6. Preferred Infrastructure Report

This chapter documents and assesses 13 design changes that Transport for NSW proposes to make to the CBD and South East Light Rail (CSELR) proposal since the public exhibition of the Environmental Impact Statement (EIS). These design changes were identified as a result of ongoing design development, issues raised by stakeholders and the community during the EIS exhibition period, as well as further refinement of the constructability of the proposal. An assessment of the difference in environmental impact for each design change demonstrates that, collectively, they would represent a positive outcome for the proposal or can be adequately managed through the application of suitable environmental management measures (refer to Chapter 8 of this Submissions Report).

Figure 6.16 Changes to configuration of the Belmore Road approach at the intersection of Belmore Road/Avoca Street/High Street

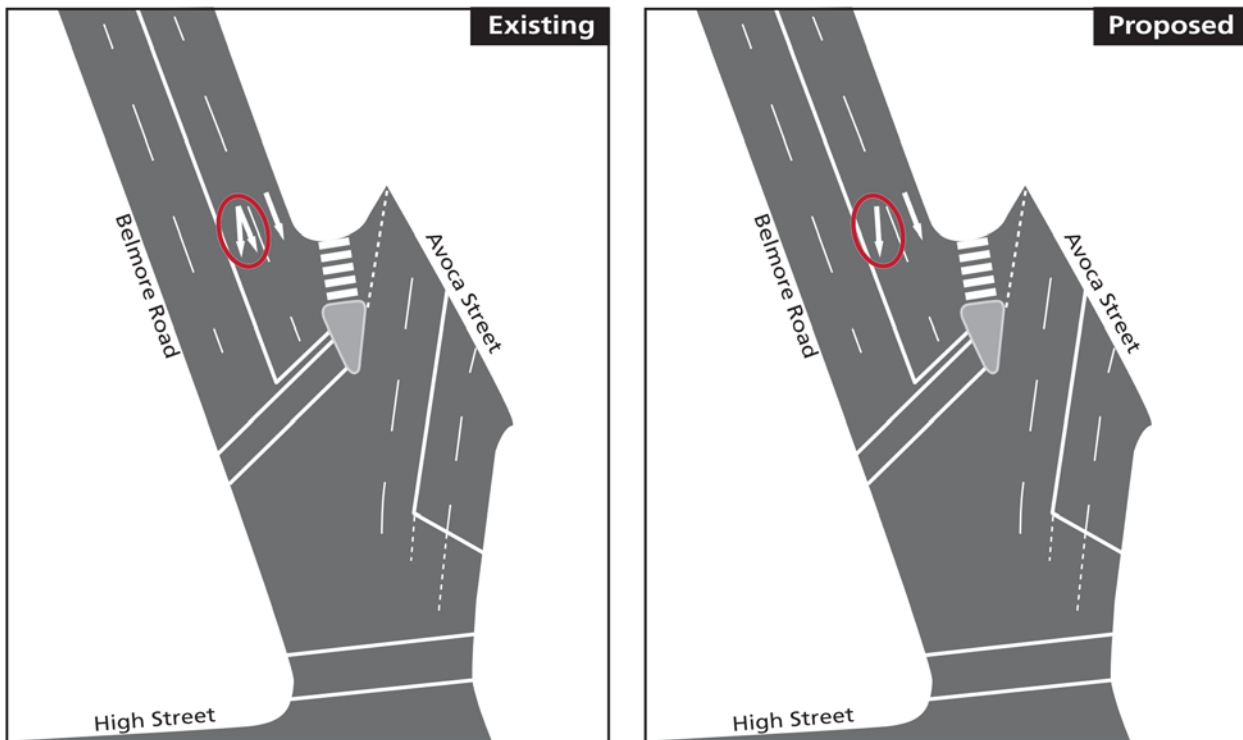
As described above, the proposed traffic configuration along Belmore Road (south, adjacent to High Cross Park) would result in one southbound general traffic lane and two northbound bus lanes. As a result of the reduction in the width of Belmore Road (south) the crossing time for pedestrians would be reduced as would the respective pedestrian clearance time required for the movement. The reduced crossing distance would reduce traffic delays associated with left turning traffic having to give way to these pedestrian movements.

With respect to the left turning traffic (from Belmore Road (north) to Belmore Road (south)), the proposed phasing of the intersection of Belmore Road/Avoca Street/High Street would remain unchanged from the EIS proposal. However, due to the reduction of a southbound traffic lane along the section of Belmore Road adjacent to High Cross Park the northern Belmore Road approach lanes would be reconfigured to remove the left hand permissible traffic movement from the inner lane of Belmore Road (refer to Figure 6.16).

Figure 6.19 Revised location for the Parker Lane substation

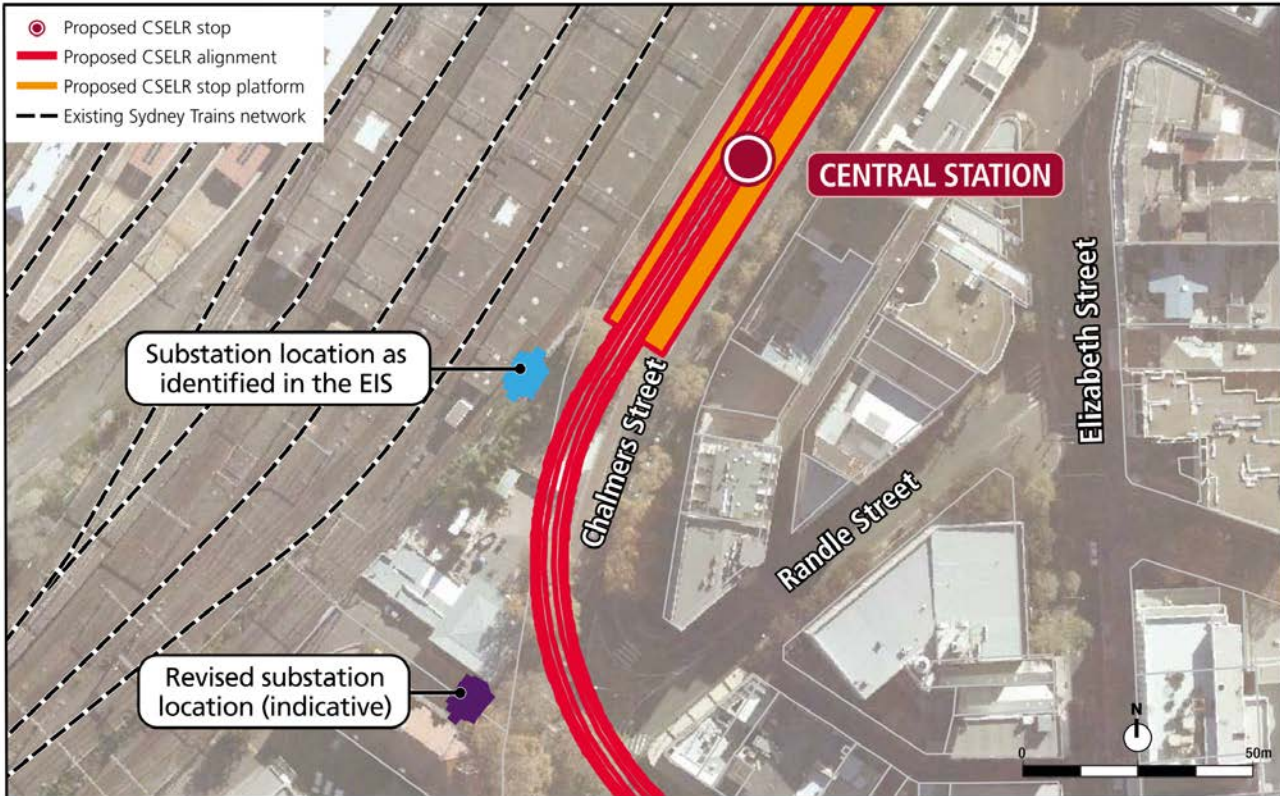
Substation location and current location	Proposed revised location
<p>Parker Lane substation</p> <p>The EIS identified this substation would be located within Parker Lane, near the intersection of Parker Lane and Hay Street, located above ground.</p>	<p>Following refinement of the design, the Parker Lane substation is proposed to be relocated to an adjoining car park area between Parker Lane and Parker Street (refer to Figure 6.19).</p> <p>The substation would be located above ground and access to this site would be via the existing car park access point on Parker Street.</p>
<p>Chalmers Street substation</p> <p>The EIS identified this substation would be located within property owned by Sydney Trains, near the Ibero-American Plaza, located above ground.</p>	<p>Following refinement of the design, the Chalmers Street substation is proposed to be relocated to an existing, disused building within Sydney Trains land to the south of the previously proposed location (refer to Figure 6.20).</p> <p>This building has been identified as a former Sydney Trains radio workshop. Access to this site would be via an existing laneway access point which currently provides access to the Sydney Trains Prince Alfred substation.</p>

Figure 7.4 2021 inbound morning peak CSELR line load

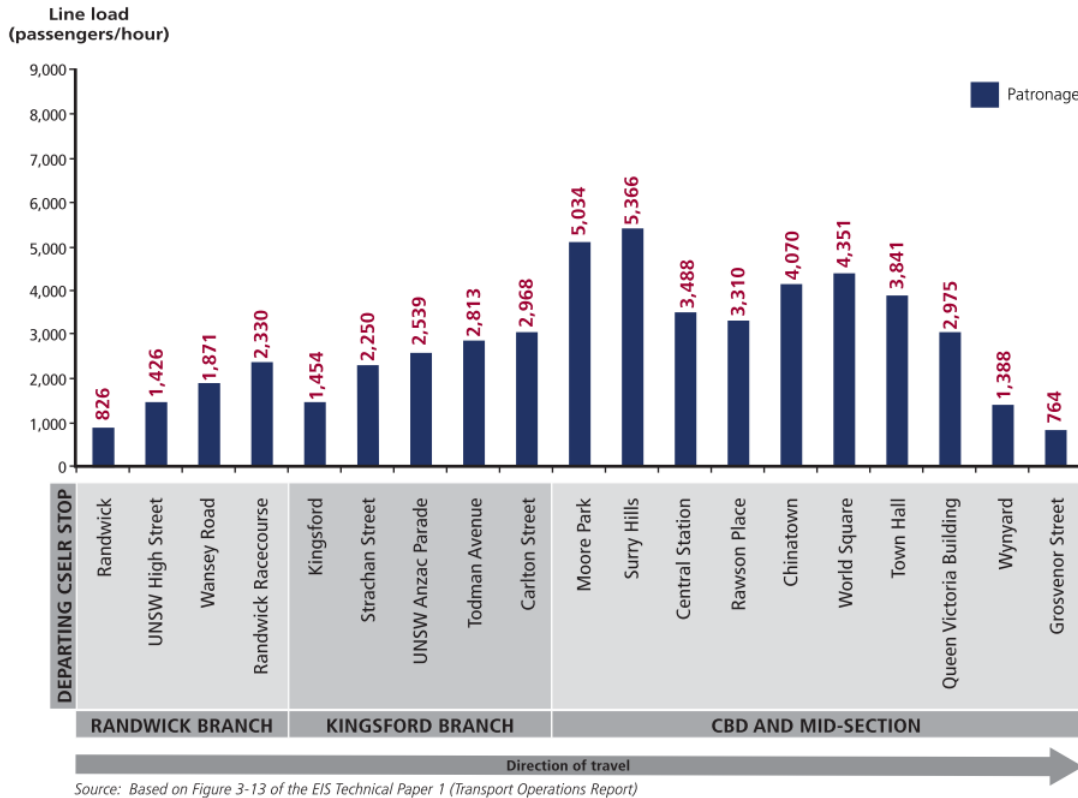
Figure 9.8 and Figure 9.9 of the EIS (Volume 1A) identified the anticipated inbound and outbound passenger line loadings and LRV capacity volumes during the morning peak at commencement of light rail operations. It has been identified that these figures could be interpreted to infer that the CSELR would be at close to 100 per cent capacity at some stops at commencement of operations. This interpretation of these figures is not correct and clarification of this issue is provided below.

Each of the figures presented in the EIS showed information for two different operational frequencies. The *percentage of CSELR capacity consumed* (right hand axis of Figure 9.8 and Figure 9.9 of the EIS; Volume 1A) was based on the estimated opening, lower, operational LRV frequency with a capacity of up to 6,000 passengers per hour. At this operational frequency some stops, such as the Carlton Street, Todman Avenue and Surry Hills stops are anticipated to be at between approximately 85 to 95 per cent capacity, at the commencement of operations.

However, following commencement of operations, the CSELR proposal has the capability to increase the frequency of LRVs to an operational capacity of up to 9,000 passengers per hour (left hand axis of Figure 9.8 and Figure 9.9 of the EIS; Volume 1A) if it is identified that there is sufficient demand for this level of service. Once the operational capacity of the CSELR proposal has been increased, LRVs would travel with a greater frequency and the overall percentage of the capacity consumed would be reduced.

Figure 7.6 2021 morning peak CSELR boarding and mode of access by light rail stop

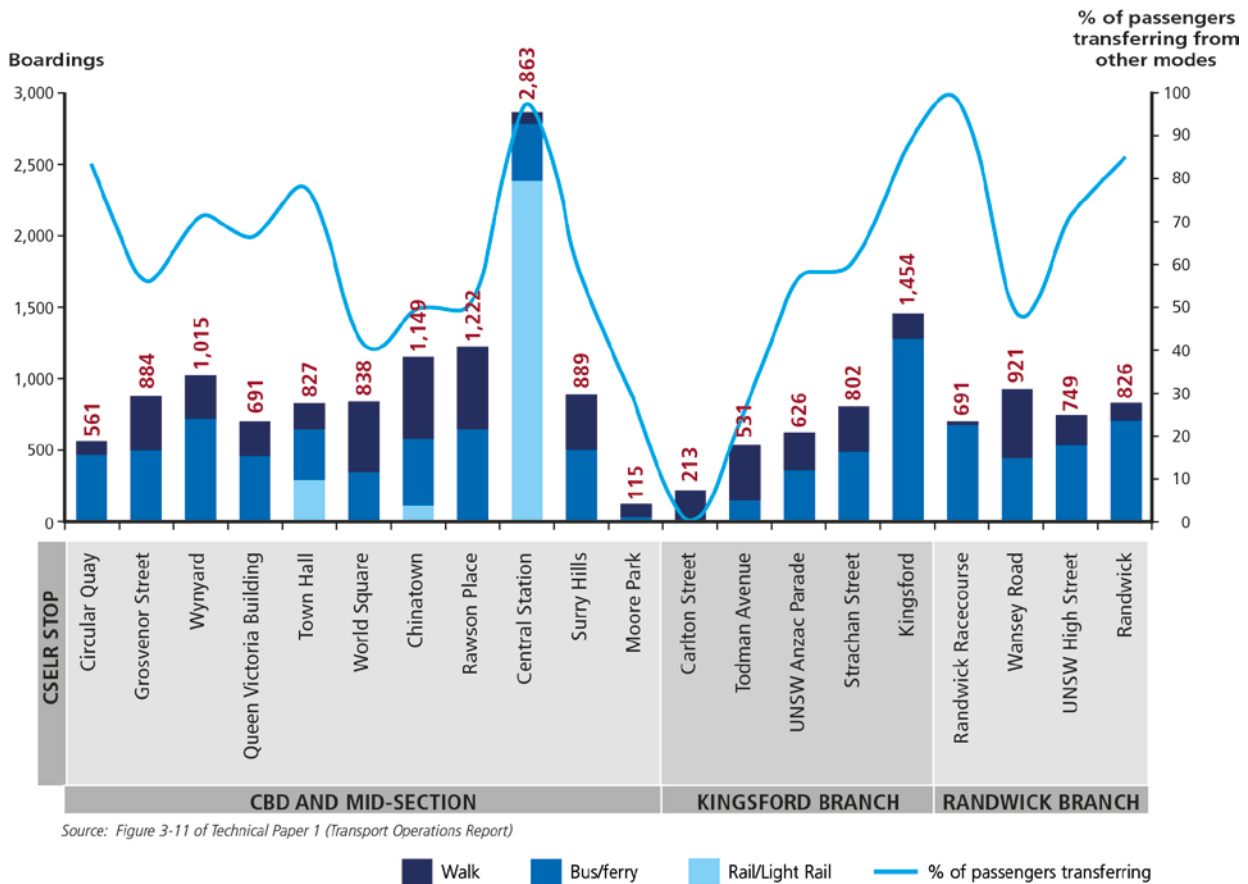
Figure 9.7 of the EIS (Volume 1A) identified the anticipated morning peak CSELR boarding and mode of access by light rail stop. It has been identified that the anticipated boarding figures for light rail at the Surry Hills stop appeared to be too large.

It is noted that an error does exist in the graph presented in the EIS (and corresponding Figure 3-11 of the Transport Operations Report, Technical Paper 1, Volume 2). A review of this figure identified that the anticipated boarding at the Surry Hills stop were incorrect and related to the Central Station stop, not the Surry Hills stop. The correct boarding and alighting figures for 2021 and 2036 were, however, presented in the Precinct Plan for Central Station (section 7.3.10 of the EIS *Transport Operations Report*, Volume 2).

Figure 7.7b Proposed construction haulage routes for the Surry Hills Precinct

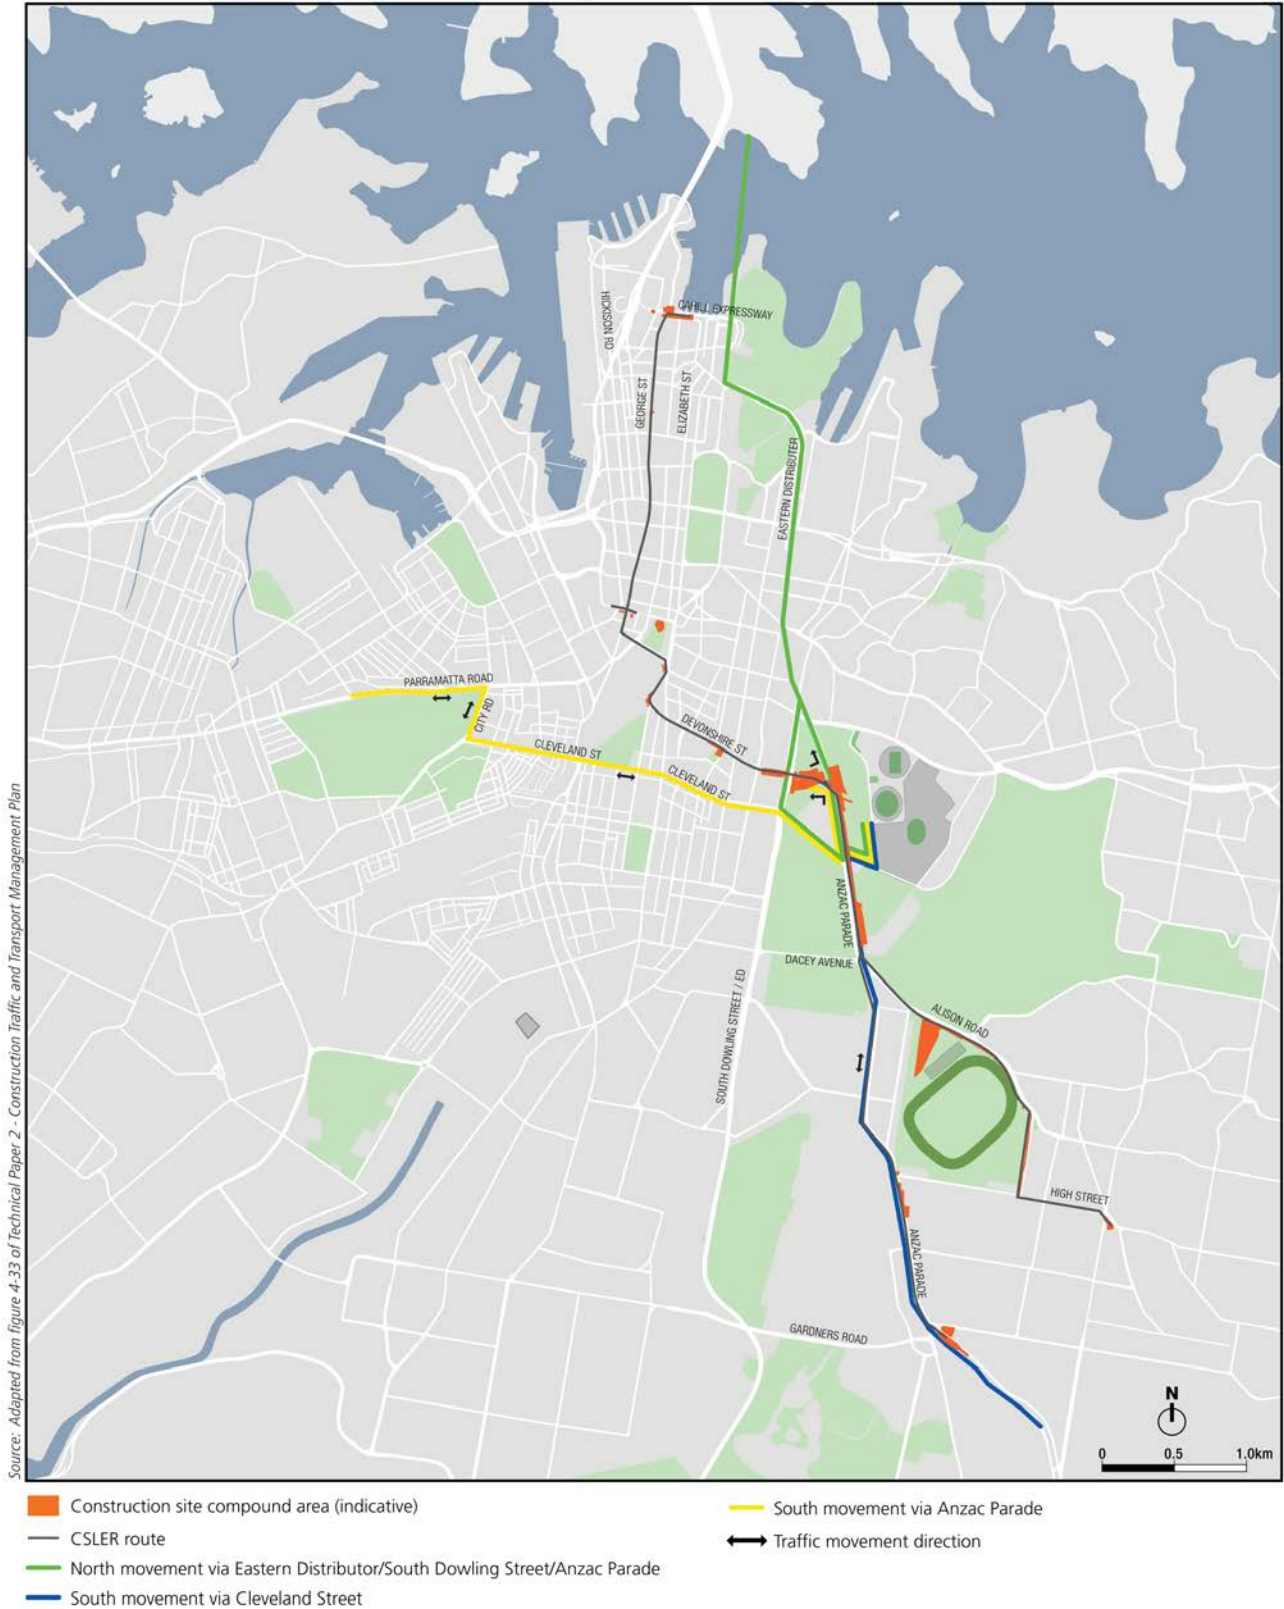
- Page 6-32 to Page 6-37 of the EIS (Volume 1A) — Figure 6.3 to Figure 6.5 and Figure 6.7 incorrectly showed the proposed haulage routes and site compound areas for the south-east sector of the proposal. The alignment of the haulage routes and compound sites had been incorrectly transposed and were intended to line up with the existing road network. The revised maps are shown as Figure 7.7a to Figure 7.7d below.
